Item Name: Skidtube with Standard Wearplates Fits LH or RH

DART SERVICE INSTRUCTION

TO AMEND INSTALLATION INSTRUCTIONS IIN-D117-762 REV. E AND INSTRUCTIONS FOR CONTINUED AIRWORTHINESS ICA-D117-762 REV. 4

A	NEW ISSUE	RF	17.01.09
REV.	DESCRIPTION	BY	DATE
DESIGN	RF	DART AEROSPACE, LTD EUGENE, OR	
DRAWN	RF		
CHECKED	WK	DRAWING NO.	REV.A
MFG. APPR.	N/A	DSI 9771	SHEET 1 OF 2
APPROVED	HS	TITLE	SCALE
DE APPR.		GHL UPGRADE KIT	NTS
DATE	17.01.09	COPYRIGHT ©2017 BY DART AEROSPACE USA, INC THIS DOCUMENT IS PRIVATE AND CONFIDENTIAL AND IS SUPPLIED ON THE EXPRESS CONDITION THAT IT IS NOT TO BE USED FOR ANY PURPOSE OR COPIED OR COMMUNICATED TO ANY OTHER PERSON WITHOUT WRITTEN PERMISSION FROM DART AEROSPACE, LTD.

FIGURE 1 - GH L UPGRADE INSTALLATION

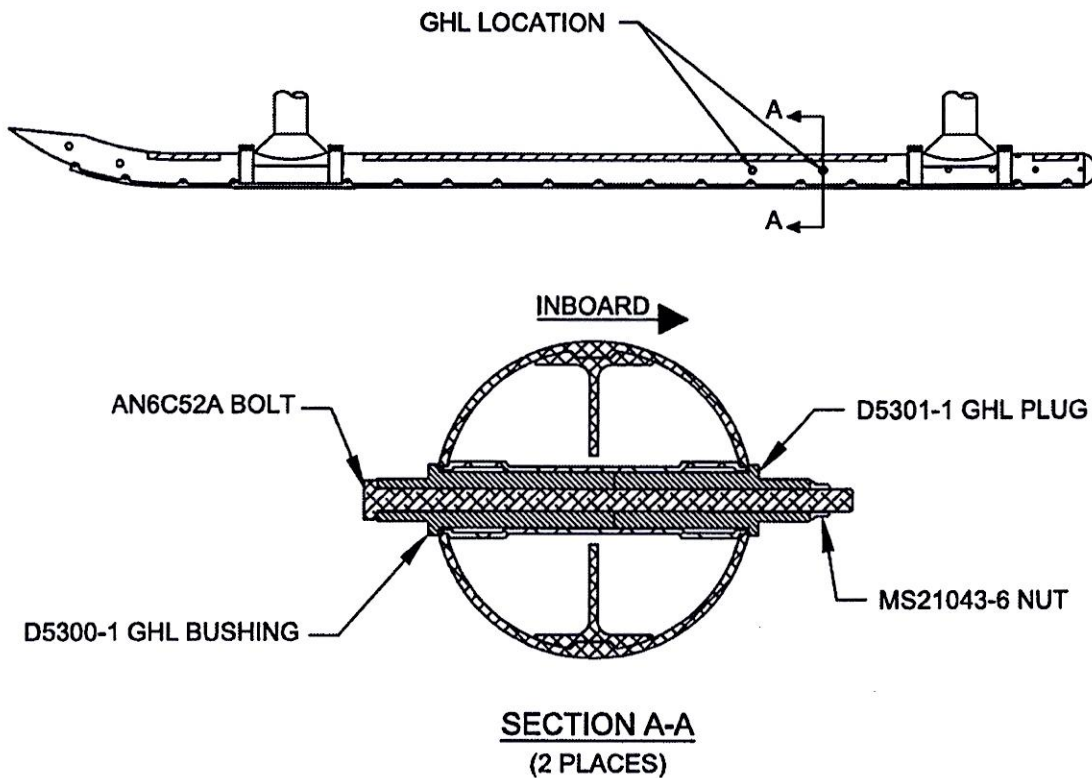
The purpose of this Dart Service Instruction (DSI) is to replace the ground handling lugs (D3864-1 Bushings, AN6C51A Bolts and MS21043-6 Nuts) on the D117-762-XXX Skid tubes with a structurally superior lug design (D5300-1 Bushings, D5301-1 Plugs, AN6C52A Bolts, MS21043-6 Nuts) as shown in Figure 1. The new hardware will be included in D117-762-011 @ CHG 004 and subsequent.

- 2.1 Loosely install (qty 2) D5300-1 GHL Bushing & (qty 2) D5301-1 GHL Plug wet with Proseal 890 or MIL-S-8802 Class B2 Sealant in location shown in Figure 1.
- 2.2 Install (qty 2) AN6C52A Bolts and (qty 2) MS21043-6 Nuts in accordance with Figure 1. Clean up squeezed out Proseal and apply fillet seal around D5300-1 & D5301-1.
- 2.3 Torque AN6C52A Bolts 160 - 190 in-lbs (18.1 - 21.5 N-m).

ITEM	QTY -011	PART NUMBER	DESCRIPTION
	X	D117-762-011	SKIDTUBE INSTALLATION
50	2	AN6C52A	BOLT
51A	2	D5300-1	GHL BUSHING
51B	2	D5301-1	GHL PLUG
52	2	MS21043-6	NUT

ITEM	QTY -011	PART NUMBER	DESCRIPTION
	X	D117-762-011	SKIDTUBE INSTALLATION
50	2	AN6C51A	BOLT
51	4	D3864-1	BUSHING
52	2	MS21043-6	NUT
